SUBJECT: CORRECTING INCONSISTENCIES, MINOR DISCREPANCIES AND TYPOGRAPHICAL  
ERRORS (TAC R00187/R00188) (TS 87-17) - SEQUOYAH NUCLEAR PLANT, UNITS  
1 AND 2

The Commission has issued the enclosed Amendment No. 114 to Facility  
Operating License No. DPR-77 and Amendment No. 104 to Facility Operating  
License No. DPR-79 for the Sequoyah Nuclear Plant, Units 1 and 2, respectively.  
These amendments are in response to your application dated June 24, 1987.

TENNESSEE VALLEY AUTHORITY  
DOCKET NO. 50-327  
SEQUOYAH NUCLEAR PLANT, UNIT 1  
AMENDMENT TO FACILITY OPERATING LICENSE

Amendment No. 114  
License No. DPR-77

FIGURE 5.1-1

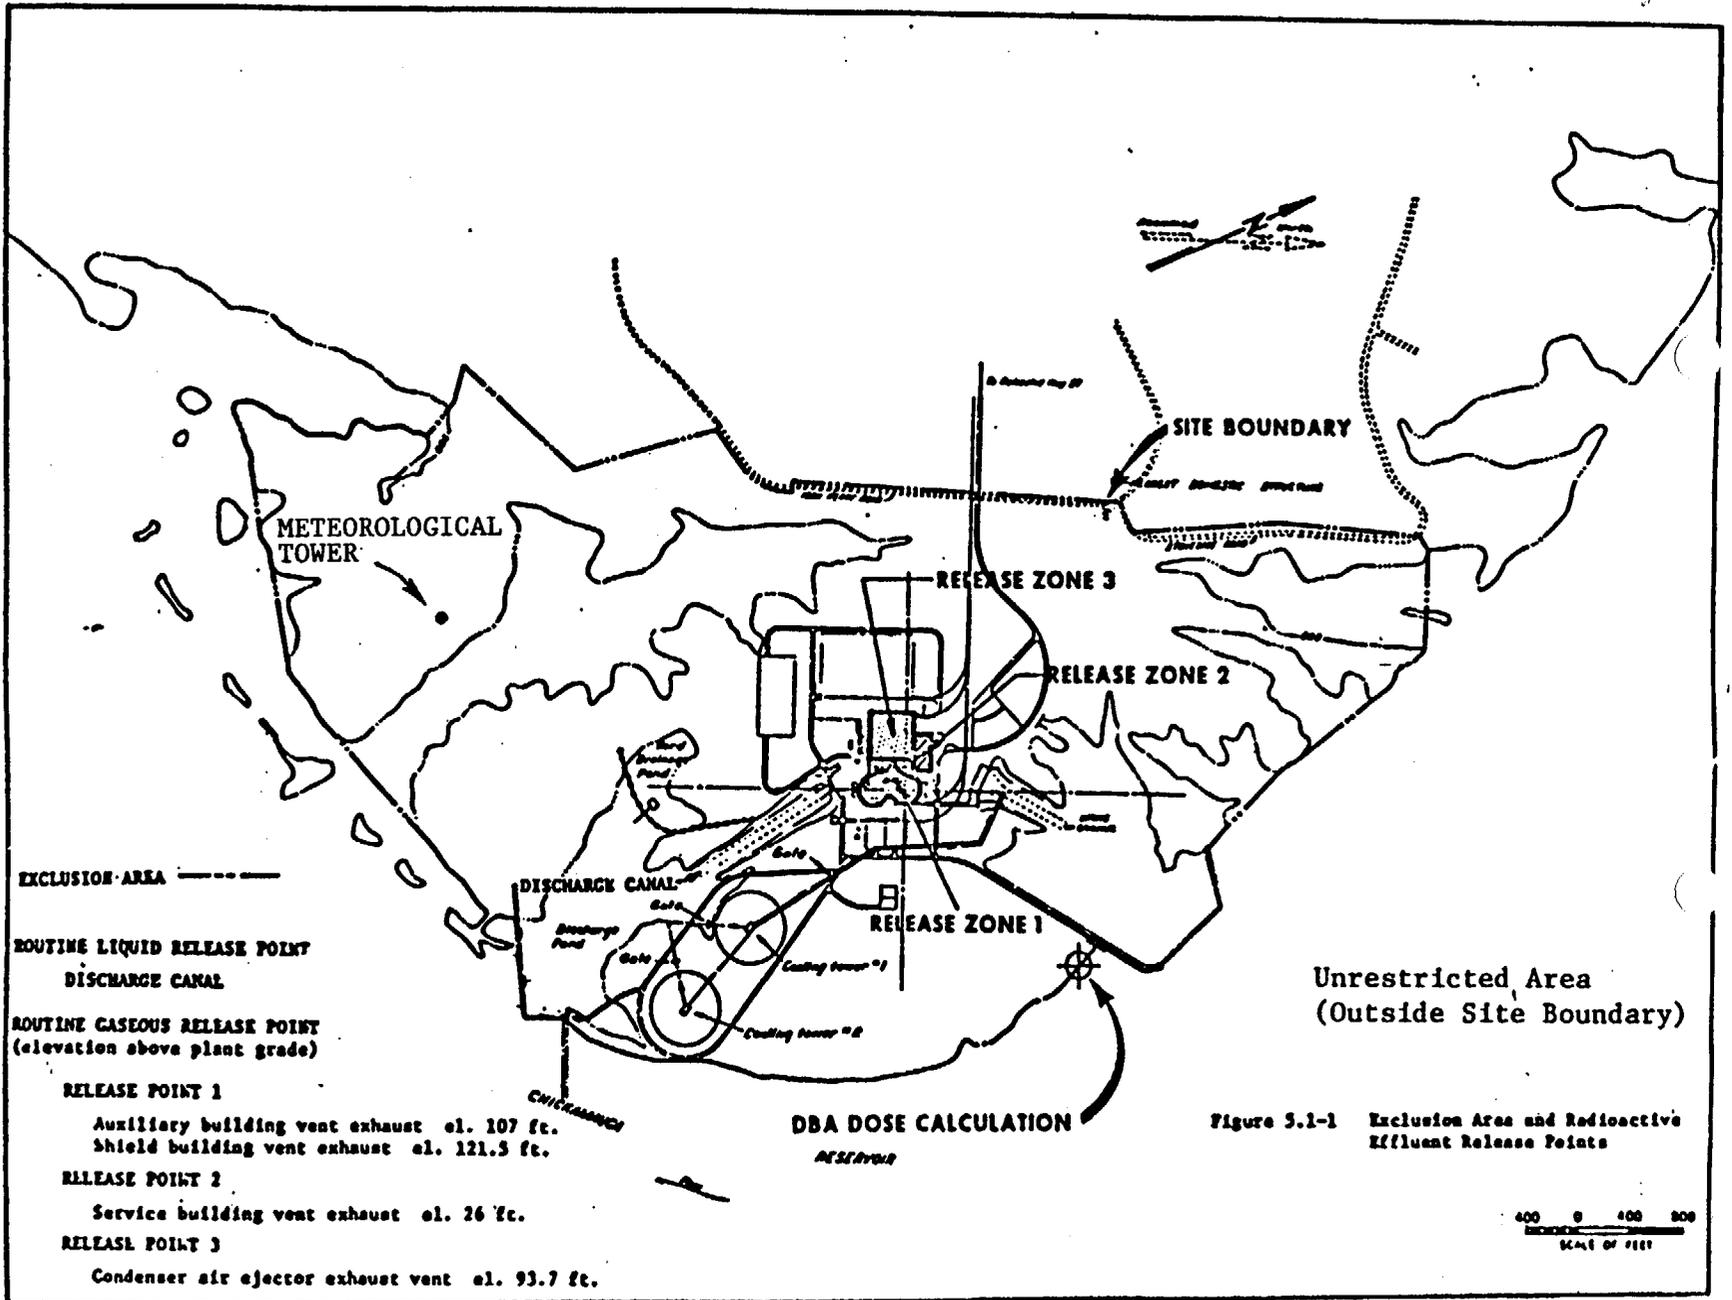
14.	5-2	Add the location of the meteorological tower to Figure 5.1-1.
15.	5-6	Correct the hydrostatic test pressures for the reactor coolant system and secondary side in Table 5.7.1.
<b>Changes That Affect Unit 1 Only</b>
